Appl. No. 10/805,179  
Amdt. dated November 3, 2005  
Reply to Office Action of August 9, 2005

**Amendments to the Drawings**

**Remarks/Arguments**

FIG.6

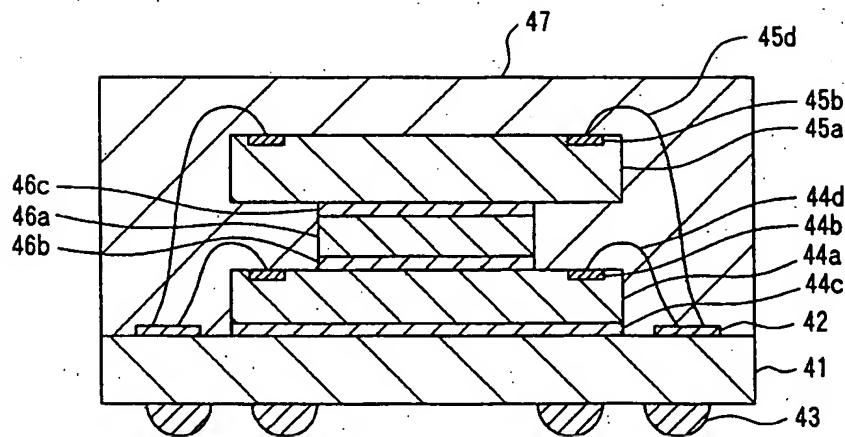
Figure 6 is objected to under MPEP 608.02(g) as lacking the legend --Prior Art--. In response, Figure 6 is amended to include the legend --Prior Art--. A replacement drawing sheet and an annotated sheet showing changes are attached.

The drawings are objected to under 37 CFR 1.84(p)(4) because reference characters 44a and 46a have both been used to designate the mirror chip. In response, applicant notes that in Figure 6, reference character 44a properly designates the lower semiconductor chip while reference character 46a designates the mirror chip. However, in one location in paragraph [0003] of the specification, mirror chip 46a is mistakenly referred to as semiconductor chip 44a. Paragraph [0003] is amended to correct this error, thereby overcoming the objections to the drawings.

The drawings are further objected to under 37 CFR 1.84(p)(4) because reference characters 44b has been used to designate both an electronic pad and a semiconductor chip. In response, applicant notes that in Figure 6, reference character 44b properly designates only the electronic pad. However, in one location in paragraph [0004] of the specification, semiconductor chip 45a is improperly designated as "44b". Paragraph [0004] is amended to correct this error, thereby overcoming the objections to the drawings.

The attached sheet of drawings includes changes to Figure 6. This sheet, which includes Figure 5, replaces the original sheet including Figures 5 and 6. In Figure 6, the legend --Prior Art-- has been added.

"PRIOR ART"
